Project: **Brick Breeden Fieldhouse – West Entrance Roof Retrofit PPA #19-0172**
Montana State University – Bozeman, Montana

ENGINEER: DCI Engineers
TO: All plan holders of record

MSU Brick Breeden Fieldhouse West Entrance Roof Retrofit

MEP ADDENDUM #1

SHEET
A1.0

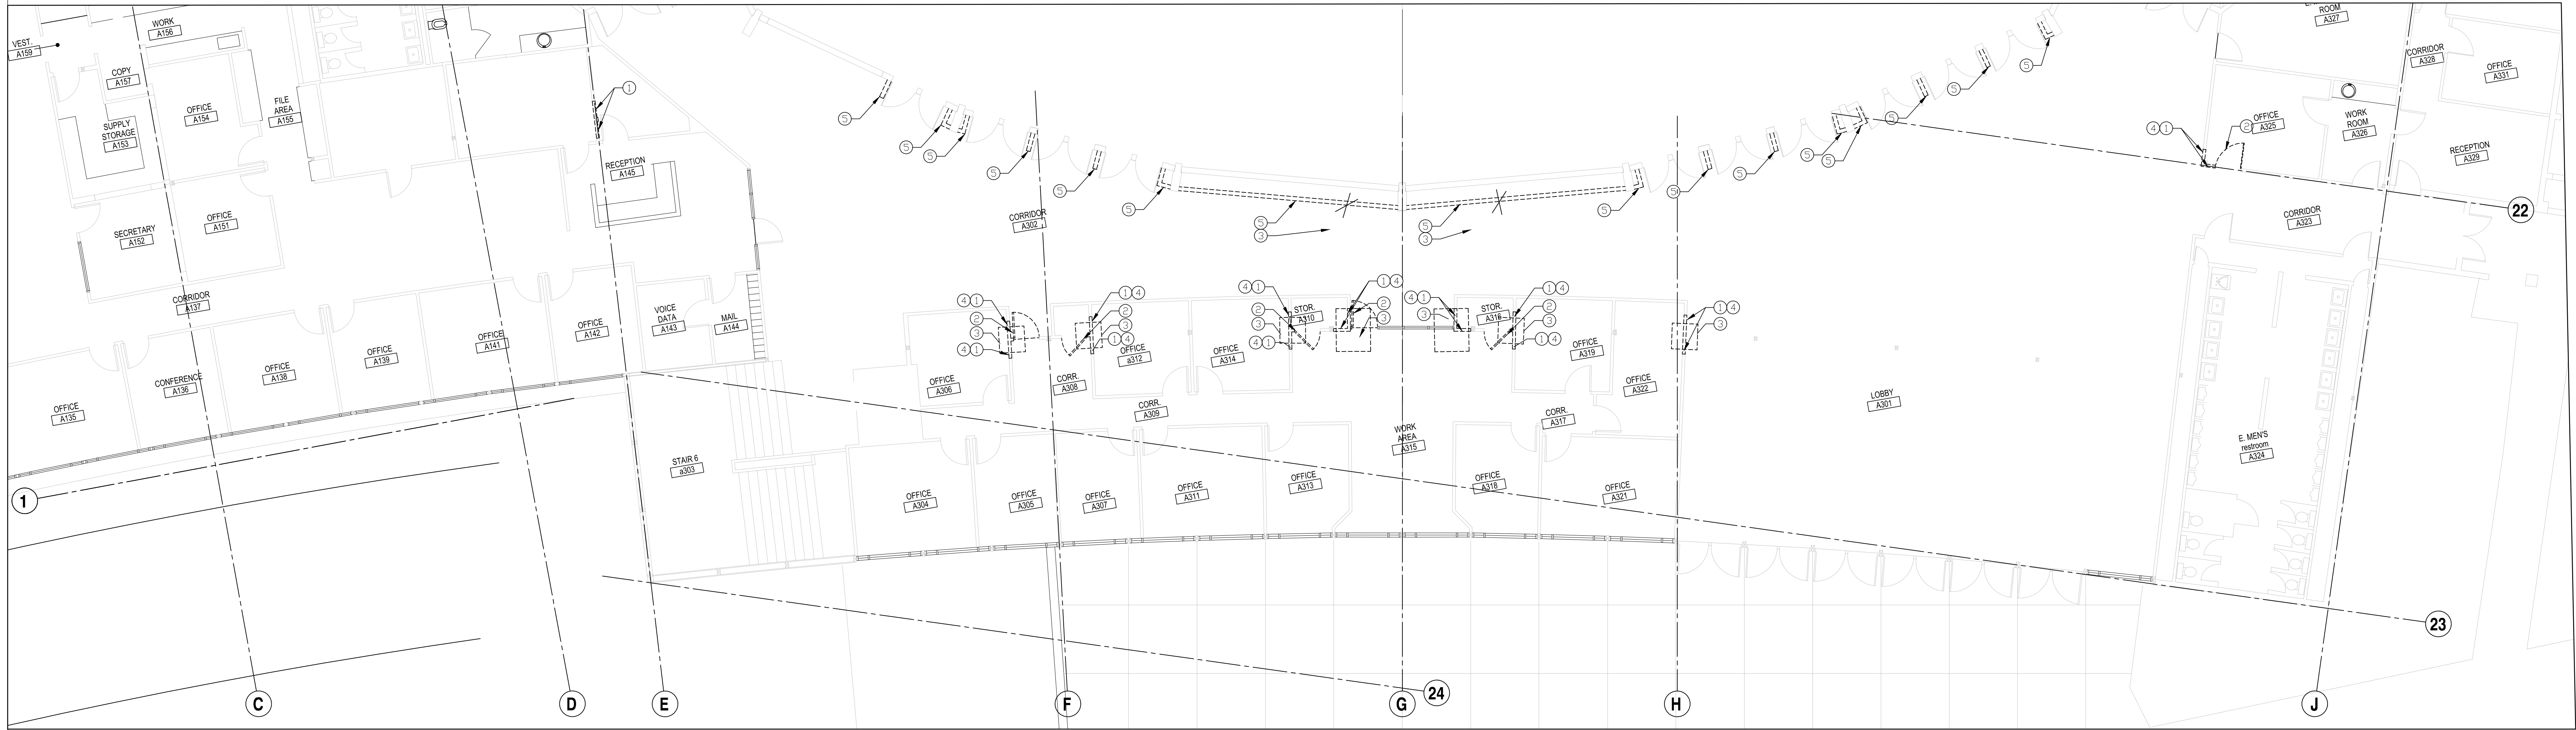
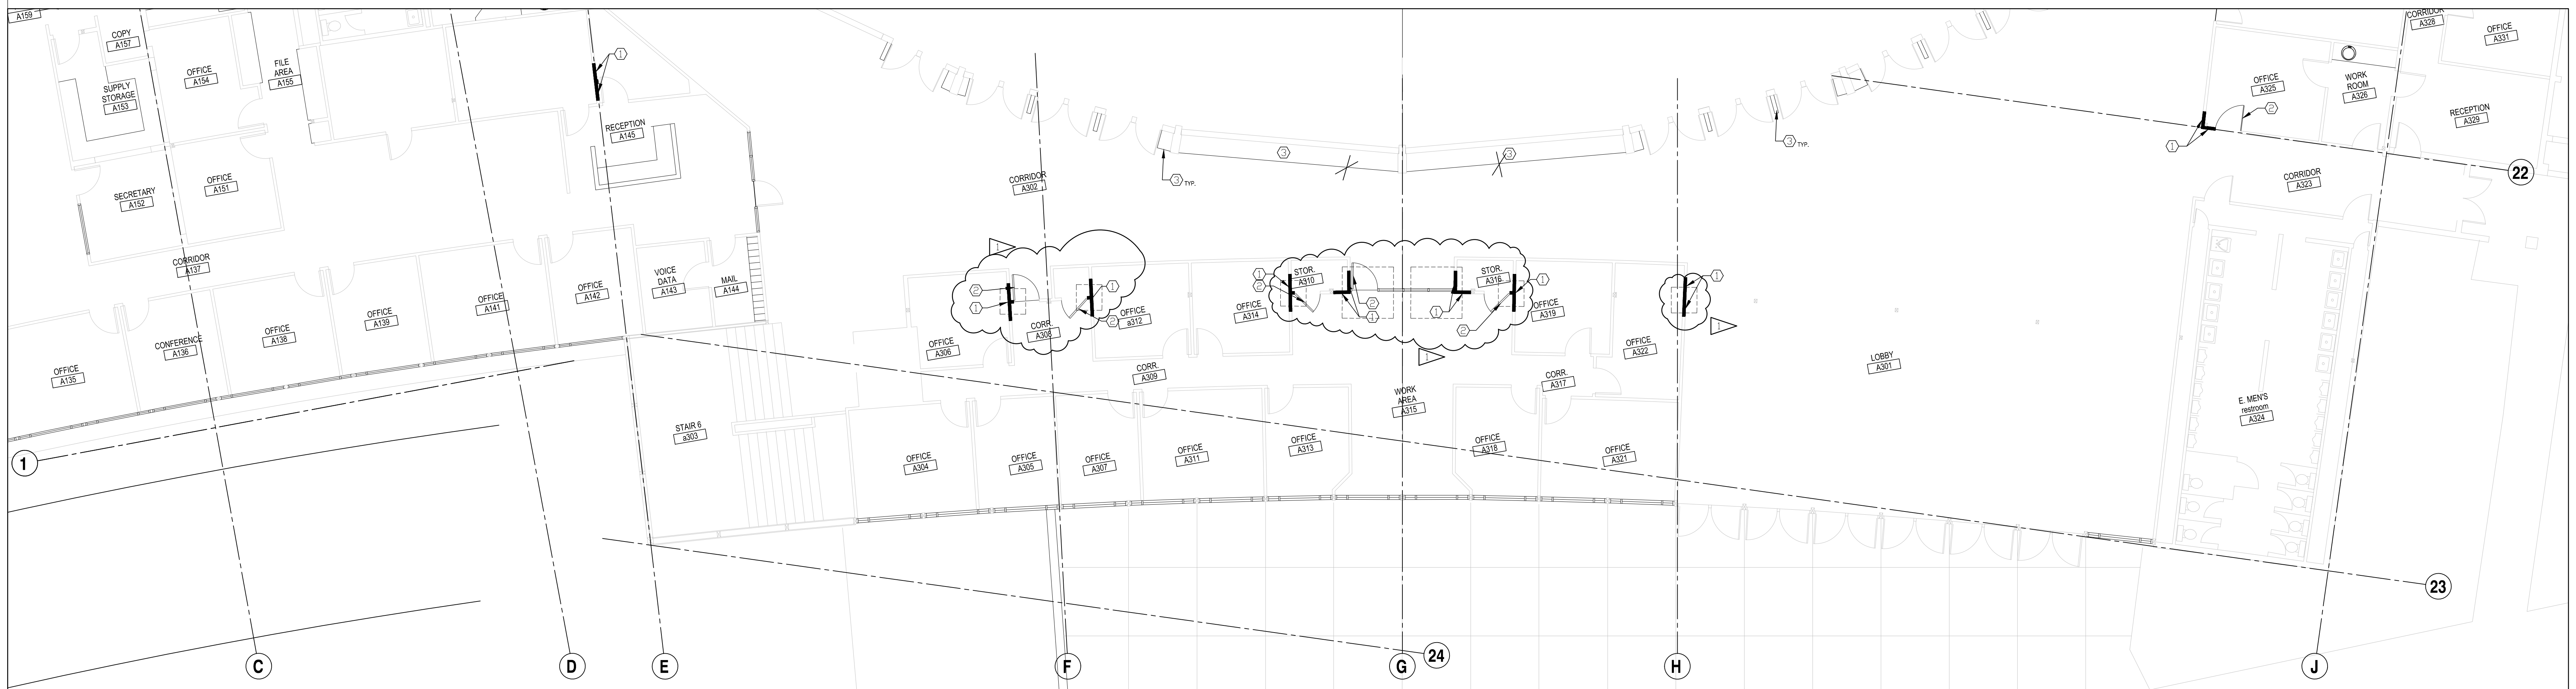
- **Demolition Notes, #5:** Revised note to reference approximate length of shoring wall to be removed and reference the original shoring drawings included in this addendum.
- **Plan Notes, #1:** Added information on wall construction to include 3-5/8" 25 GA. Metal Studs @ 16" o.c.
- **Plan Notes, #3:** Added reference to A5.1 for finish of floor where patching is required at removed shoring wall.
- **Grid F and G:** Included outline of floor demolition from structural drawings to clarify extents of wall framing to be removed and replaced.

SHEET
A1.1

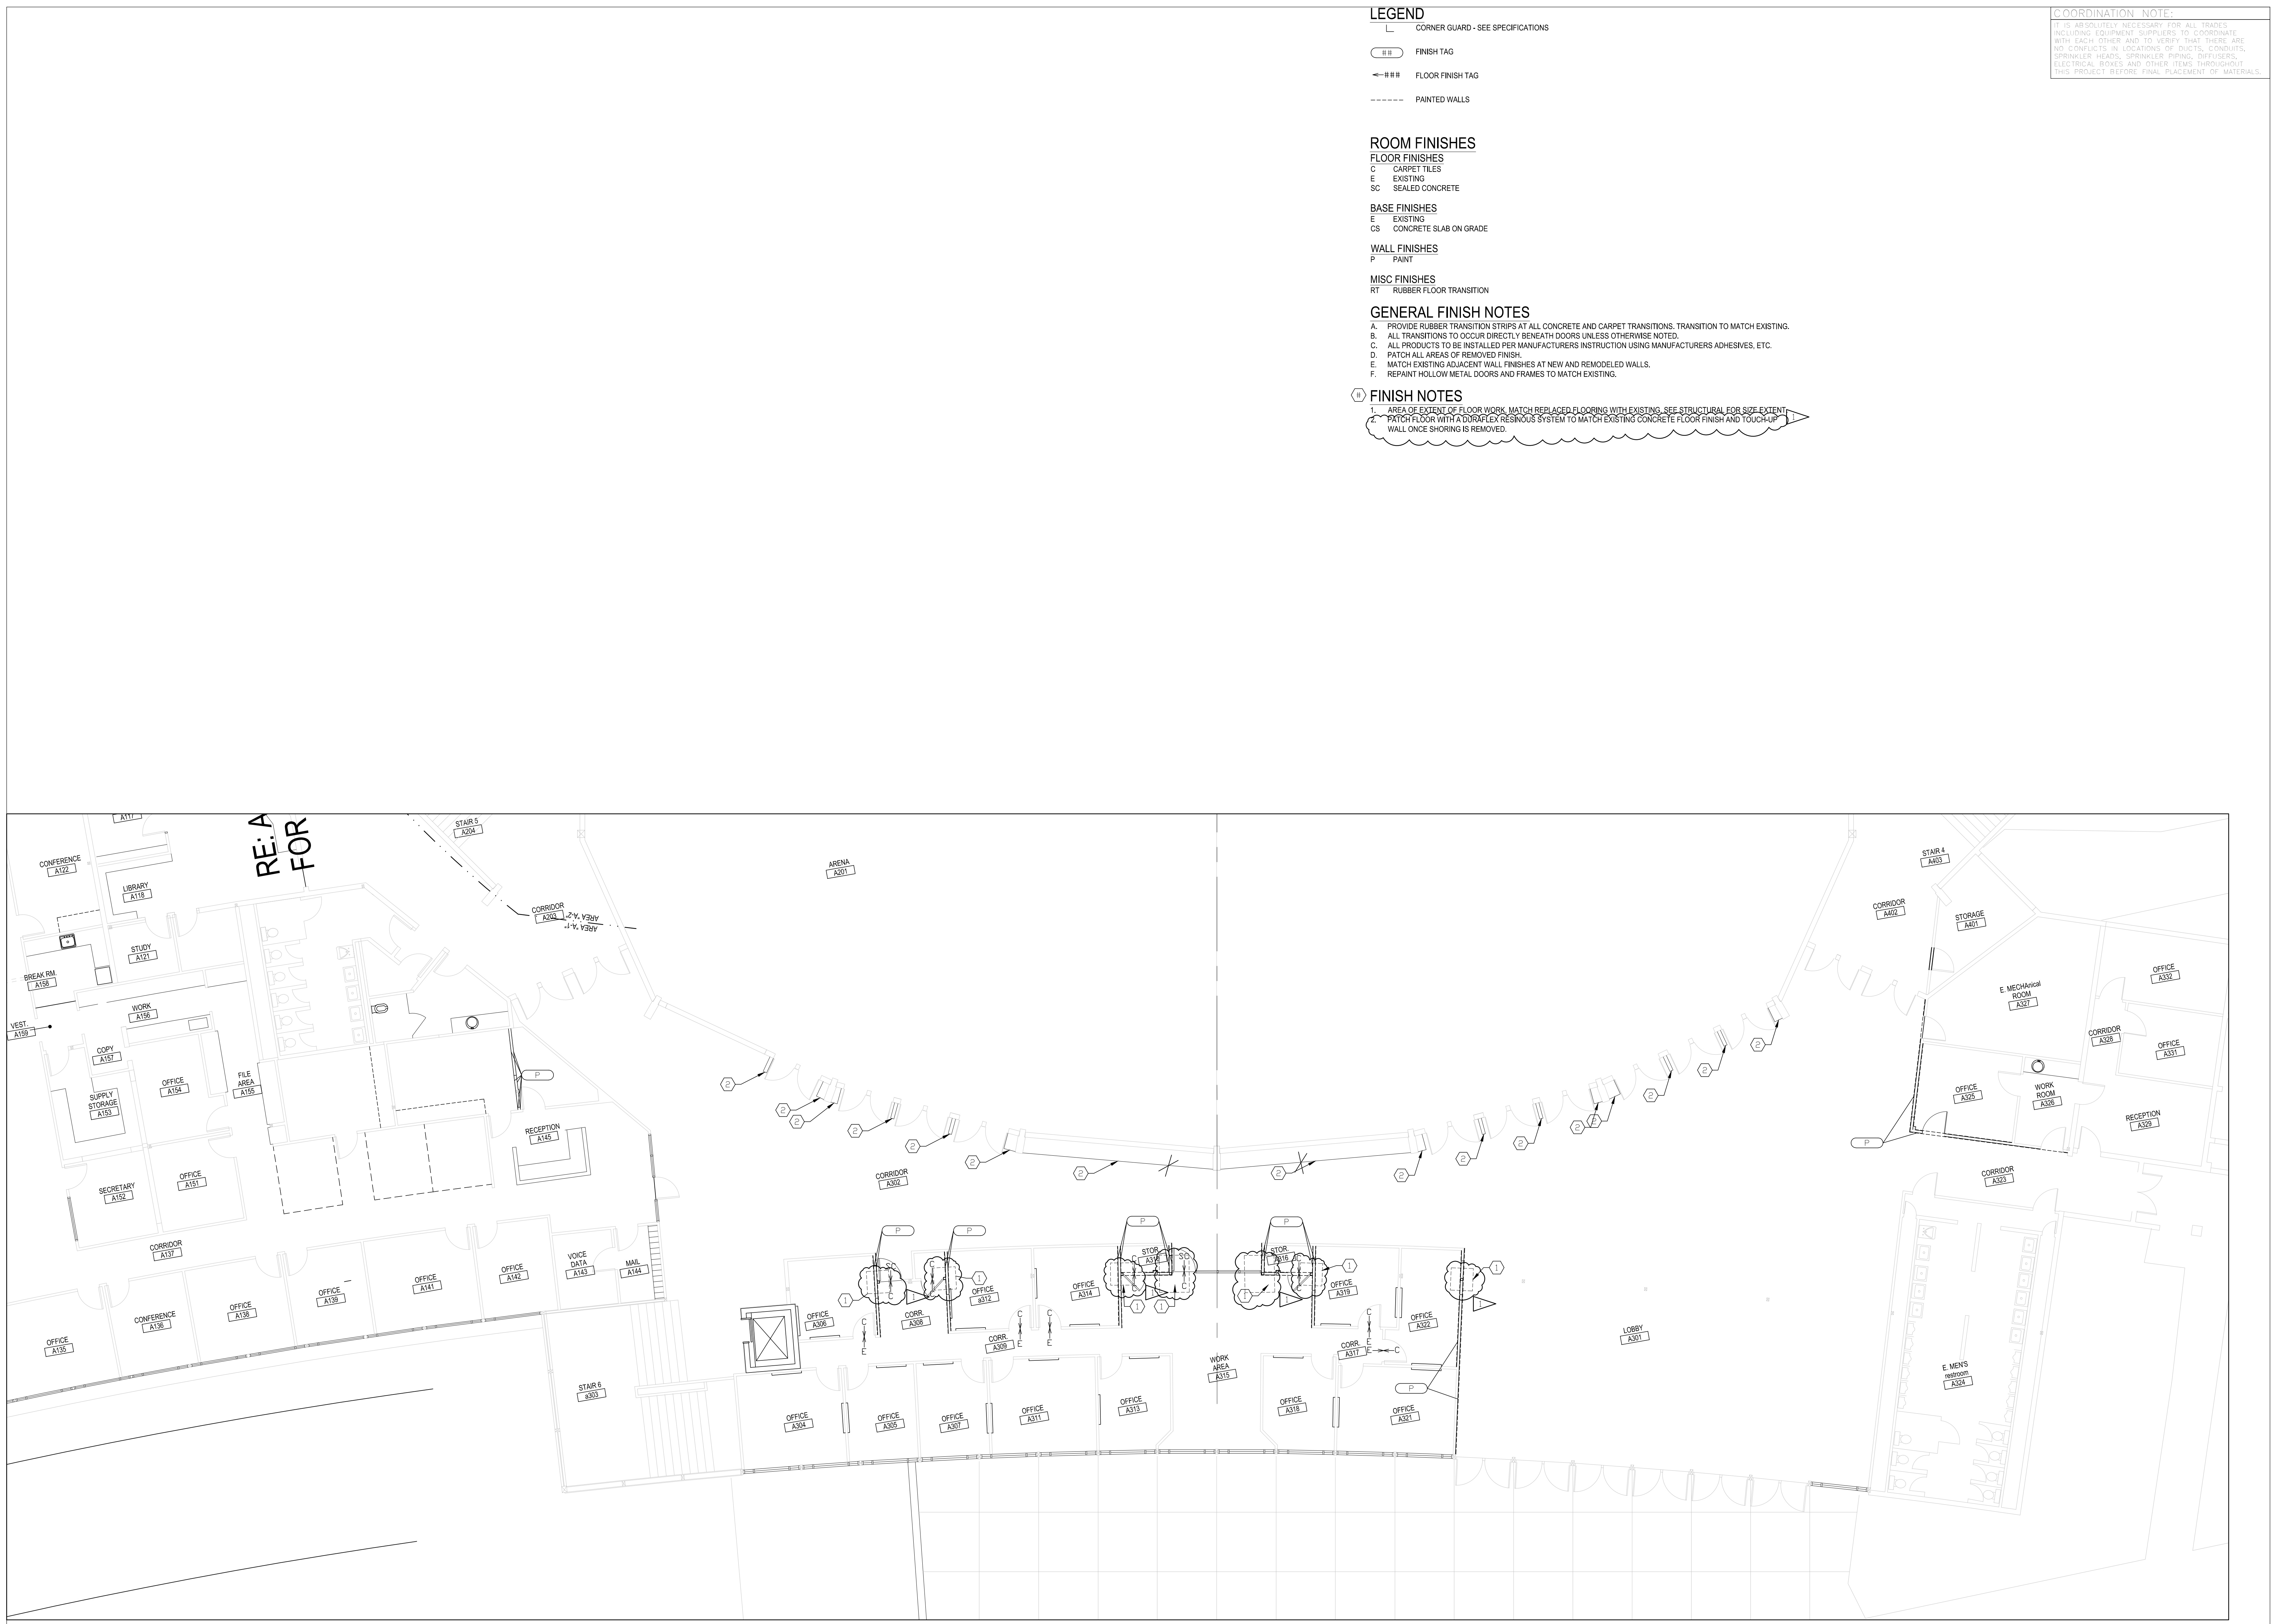
- **Roof Area C, Alternate #1:** Revised roofing area of removal and replacement to be 4,265 SF.

SHEET
A5.1

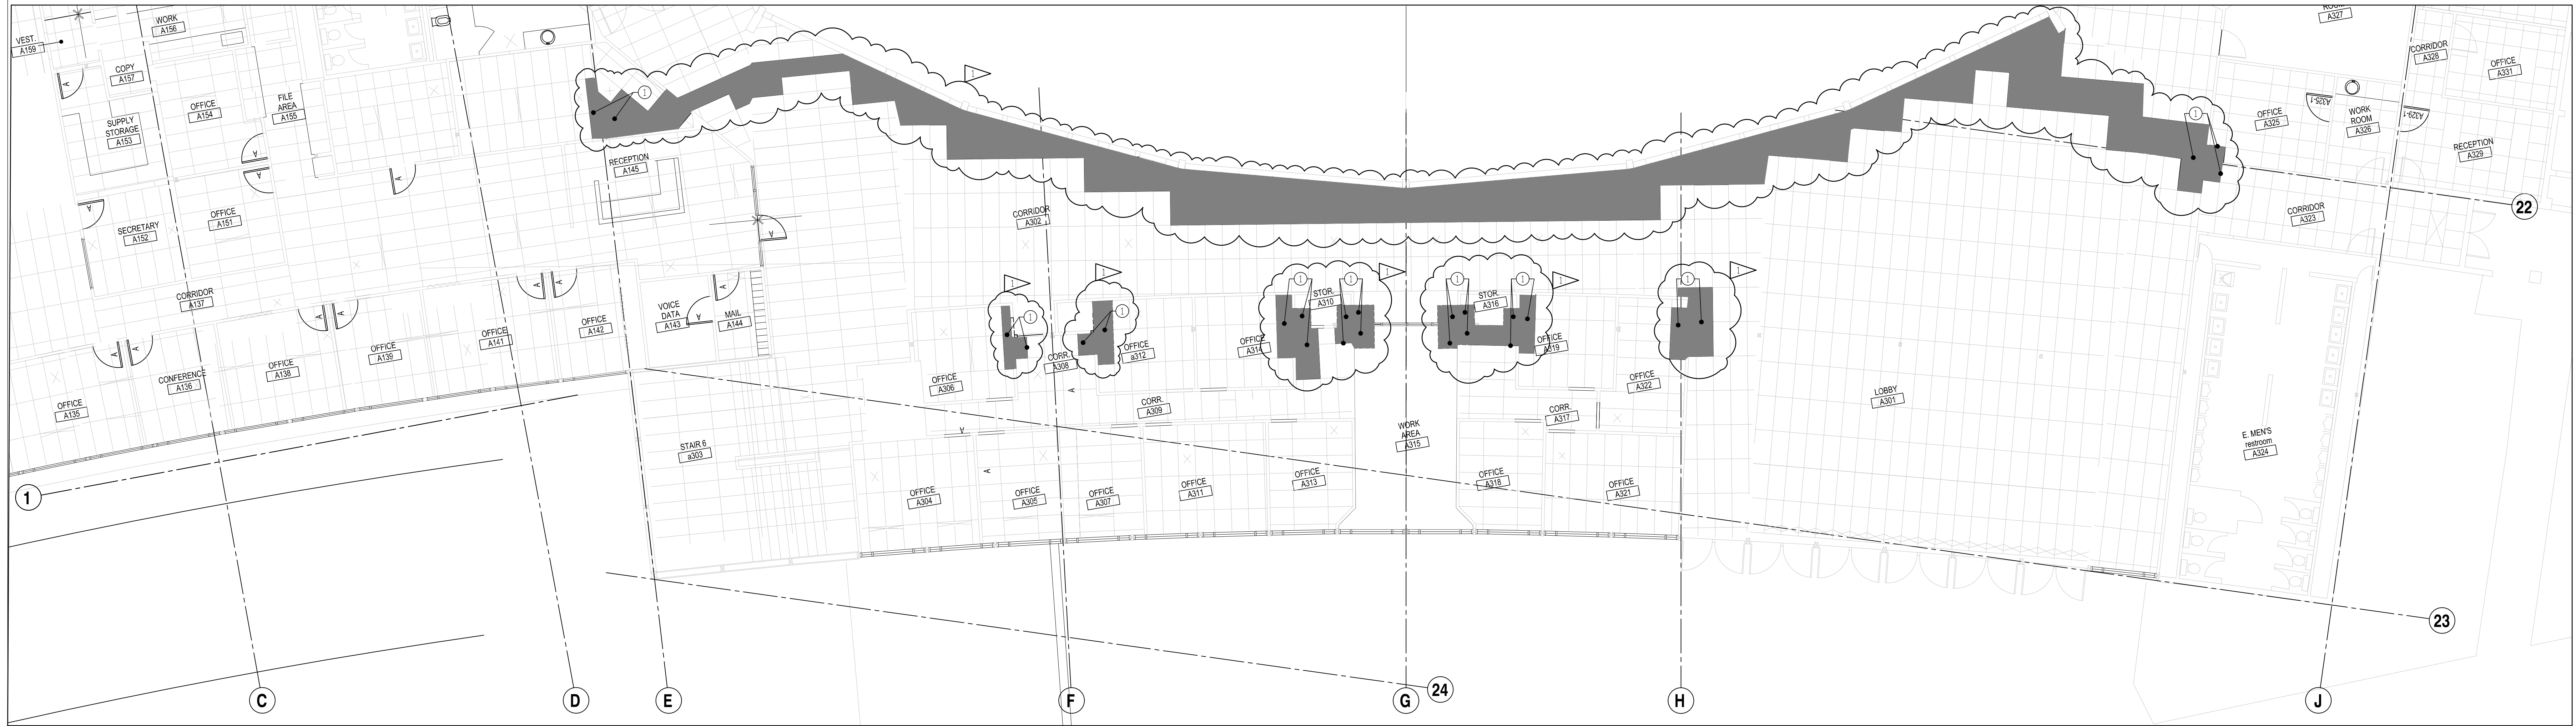
- **Finish Notes, #2:** Revised note to address floor finish at patched floor areas where temporary shoring wall has been removed.
- **1/A5.1 Finish Plan, Floor Repair Areas:** Added dashed lines clarify extents of footing work affecting floor finishes.

SHEET
A9.1

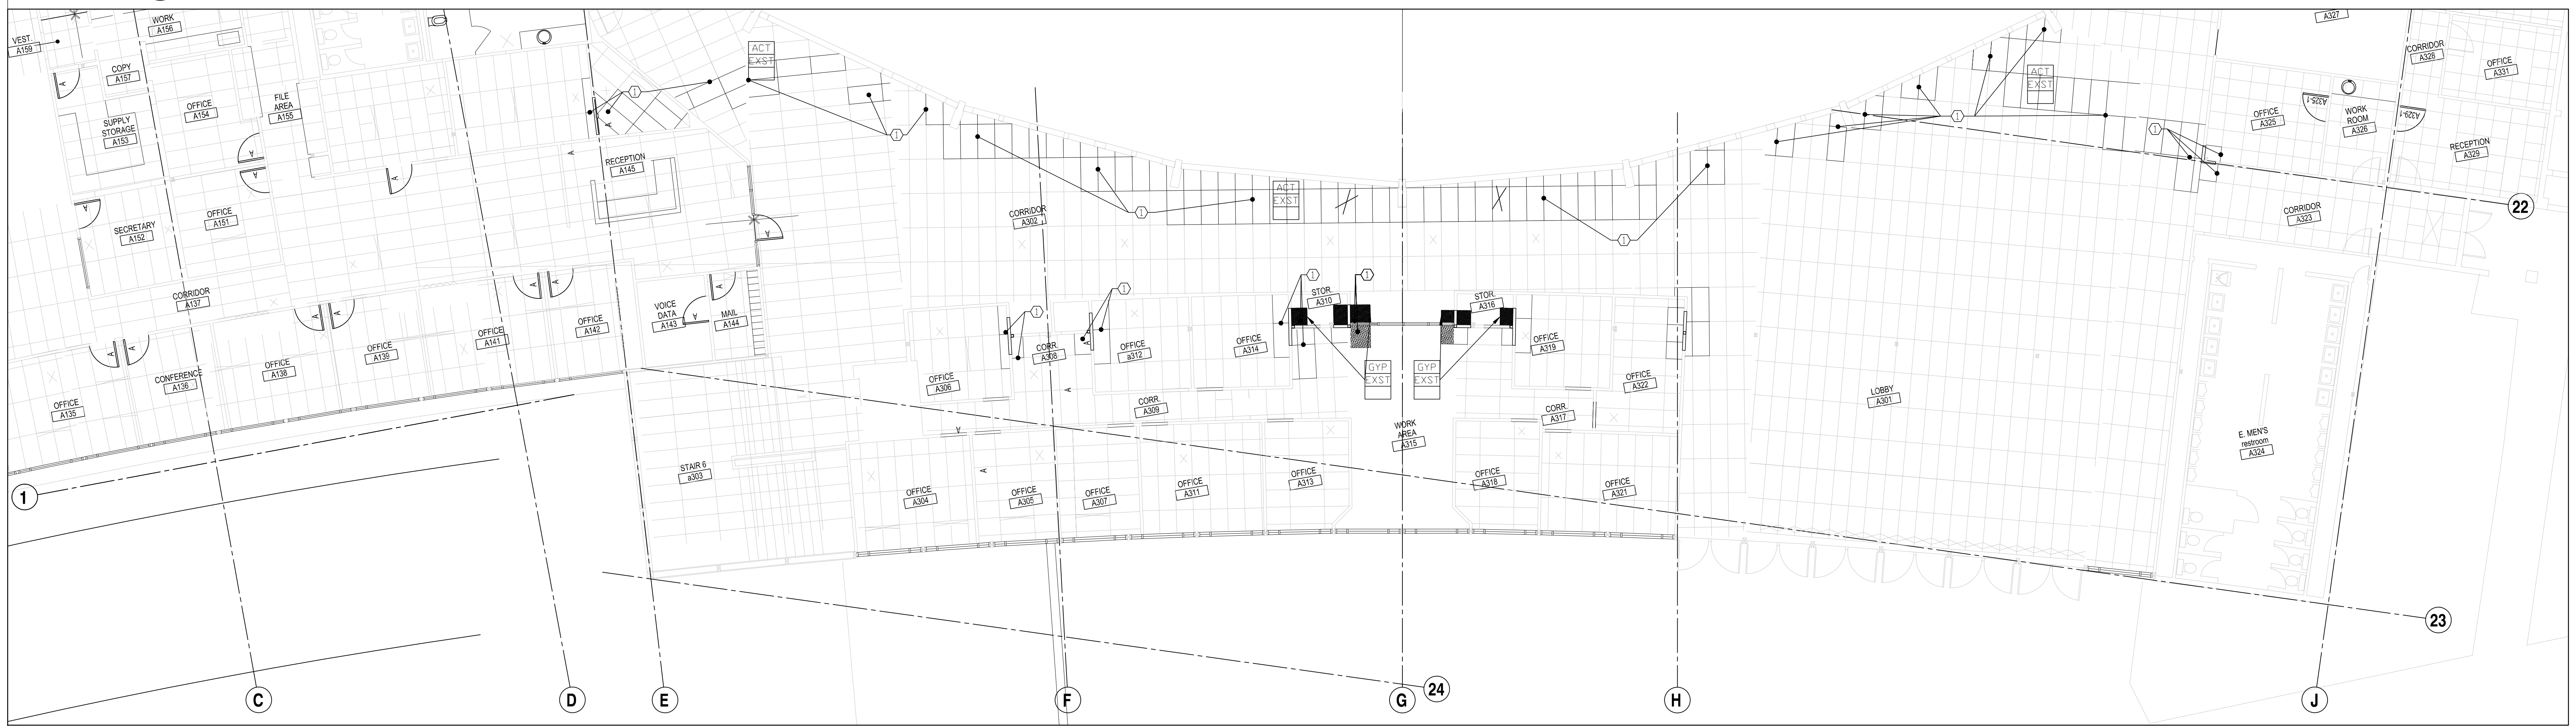
- **Reflected Ceiling Legend:** Added shaded note to clearly indicate Demo'd Ceiling areas.
- **Demo Reflected Ceiling Plan:** Added shade to ceiling areas that are to be demo'd.
